Attachment B
Utilities and Transportation Commission Comments on
Puget Sound Energy's Colstrip Study
Docket UE-120767

Figure 5-23
Gas Price and CO₂ Price interaction for Colstrip cost-effectiveness

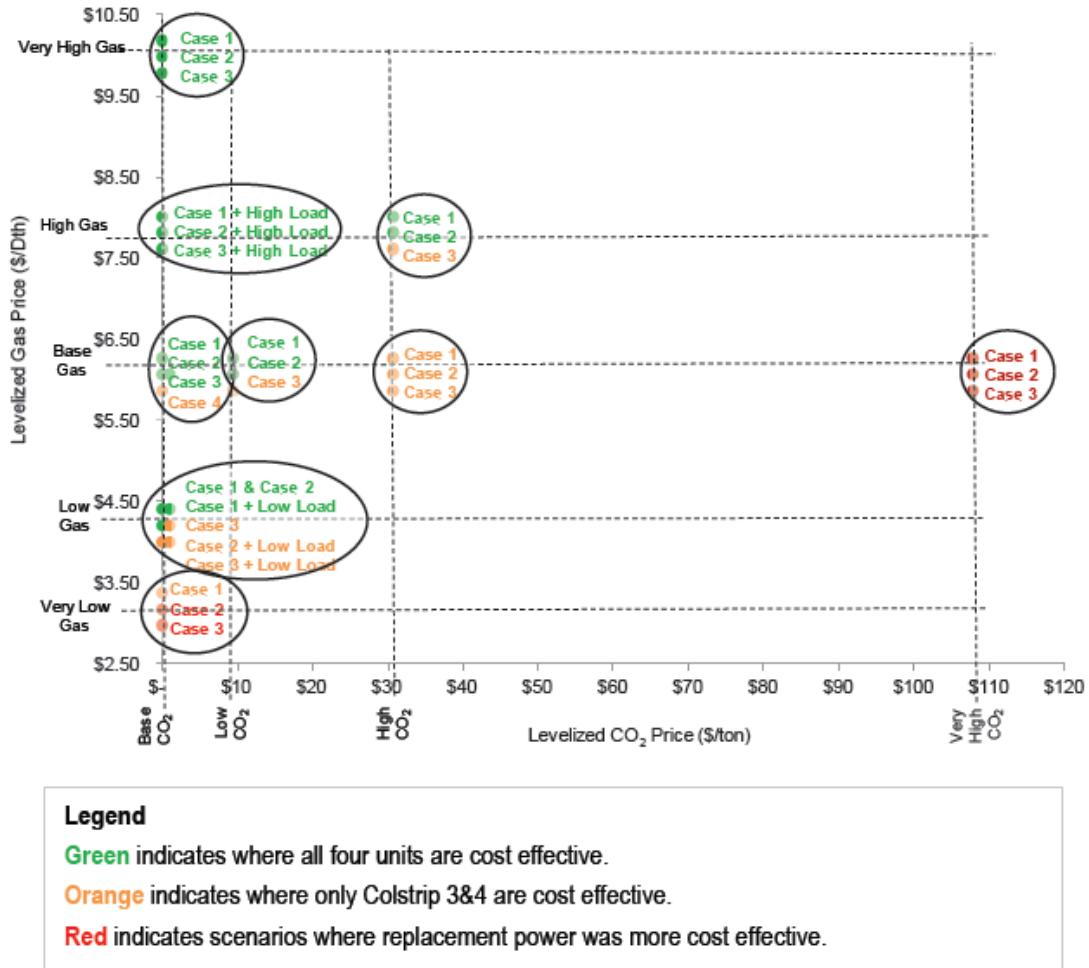
PSE examined Colstrip's operation under the Base Scenario and several other deterministic scenarios. Figure 5-23, reproduced below, illustrates which Colstrip units are cost effective under four Environmental Compliance cases, five natural gas price scenarios, three load growth scenarios, and four CO₂ cost scenarios.

For example, under Environmental Compliance 2, the combination of the low gas price scenario and the low load scenario render units 1 and 2 uneconomic.²³ If the very-low gas price scenario is substituted for the low gas price scenario all four Colstrip units are uneconomic.²⁴

With the high costs modeled in Environmental Compliance 4, units 1 and 2 are uneconomic at the Base Scenario's gas price, without factoring in CO₂ costs.²⁵

Similar trends in the reduced economics of Colstrip occur with increases in CO₂ costs. As CO₂ costs are added to the Base Scenario Colstrip units 1 and 2 become uneconomic. This trend is shown to occur somewhere above \$10 per ton of CO₂ but at or below \$30 per ton of CO₂.²⁶ Because PSE did not model any CO₂ costs between the \$10 and \$30 range, the Commission is unable to determine exactly where in this range units 1 and 2 become uneconomic.

In PSE's high gas prices and high load growth scenarios, the relative economics of Colstrip are improved even with higher CO₂ prices.²⁷

*Figure 2-6
Annual Revenue Requirement Savings in Base Scenario for Four Colstrip Cases
CCR as hazardous waste poses a bigger risk than regional haze reduction regulations.*

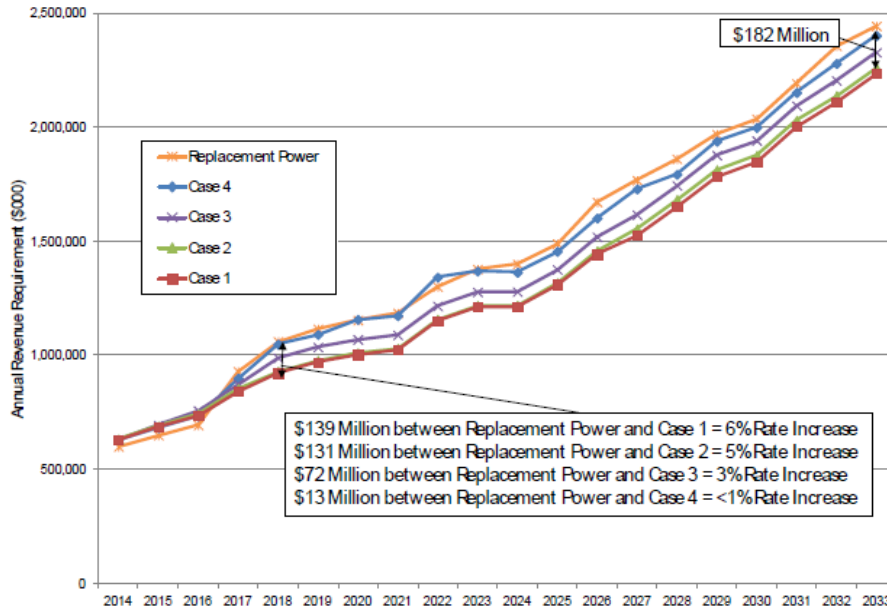
PSE provides a visual representation comparing the trend in the 20-year total power cost revenue requirement to the trend in each scenario. Figure 2-6, replicated below, shows the relationship between the four Environmental Compliance cases in the Base Scenario,

the cost of replacement power for Colstrip, and the general trend in the power cost revenue requirement over the 20-year planning period.³² While replacing Colstrip moves power costs approximately 5 percent above power costs for the Base Scenario with

environmental Compliance 2 costs, the Base Scenario itself shows a 50 percent increase in power costs per decade for the next two decades or a 5 percent increase per year without considering Colstrip replacement costs.
